October 13, 2008

**Subject: PG&E Comments on Title 20 45-Day Language for Metal Halide Luminaires;
RE: 2008 Rulemaking on Appliance Efficiency Regulations;
Docket No. 08-AAER-1A; Metal Halide Luminaires**

1. Revise the wattage ranges proposed for the low-wattage lamp compliance option

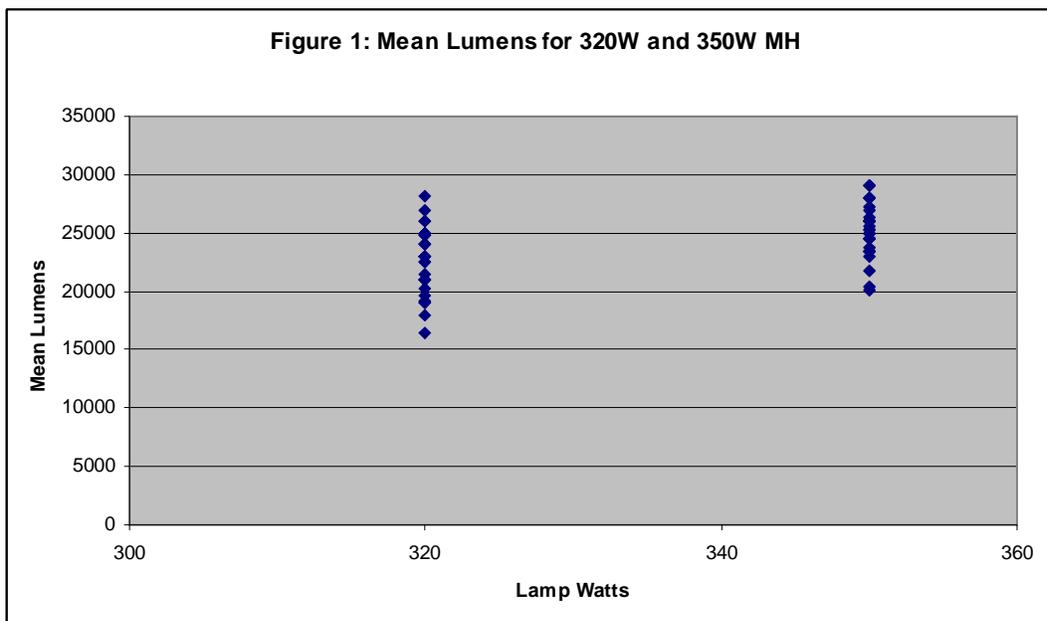
The low-wattage lamp compliance option (Section 1605.3(n)(2)(B)3) establishes wattage ranges for products seeking to meet the standard through the use of lower wattage lamps. Pulse-start metal halide lamps within these ranges provide the same light output as conventional probe-start lamps (e.g., 175W, 250W, 400W). As illustrated in Figure 1, many currently available 320W lamps provide mean lumen levels equivalent to those of the 350W lamps. As a result, we recommend reducing the upper bound of the 280W to 350W range to 335W. We were pleased to see this change made in the strawman proposal circulated by CEC staff, dated September 25, 2008.

Note: $n=32$ for 320W lamps, $n=29$ for 350W lamps.
